Oregon Water Resources Department OR: ORD278**REQUEST FOR WRITTEN APPROVAL TO USE CONSTRUCTION METHODS NOT INCLUDED IN OREGON ADMINISTRATIVE RULES 690-200 THROUGH 690-240**

Address at well site: SE 62nd Ave + SE Cooper St. Portland, OR
Brentwood Park

(2) Start Card Number(s): 136183

- (7) Diagram showing the pertinent features of the proposed well design and construction (attach additional pages if needed):

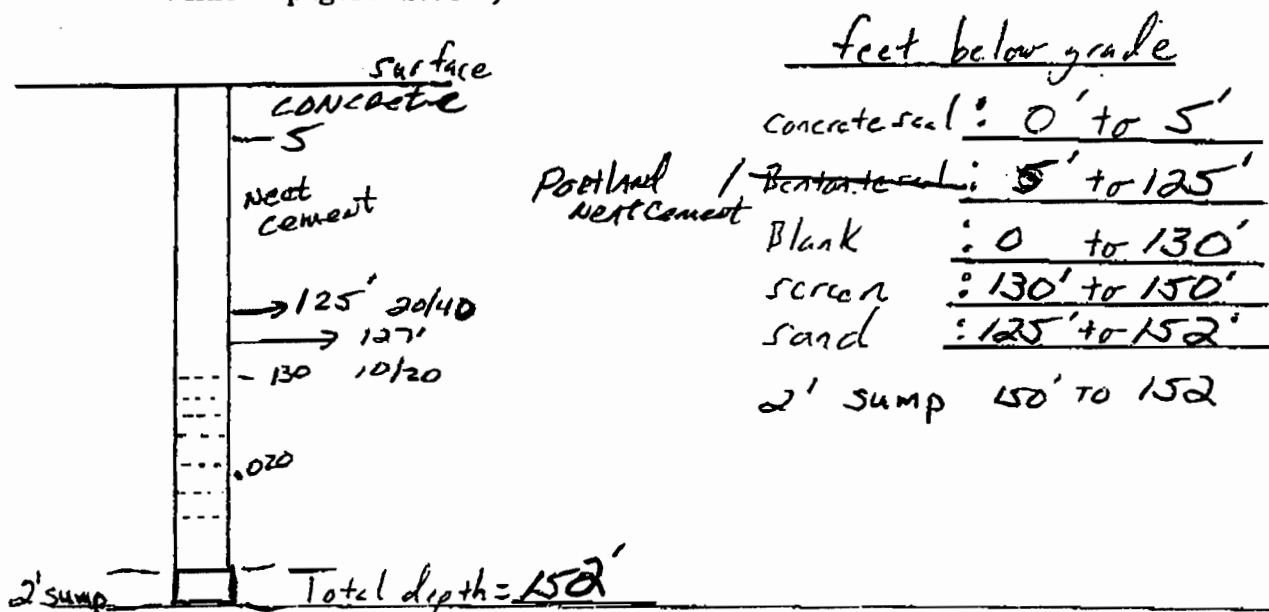
(5) The unusual conditions which necessitate this request: 1' Pre sump at Bottom
of well for silts to settle. 2' concrete from 0-5' as

putting 14" 2' Below Bottom of screen instead of the
Reg. Required 1' concrete 0-5' instead of the normal
0-1' Monitoring wells - 4" diam PVC well screen & casing
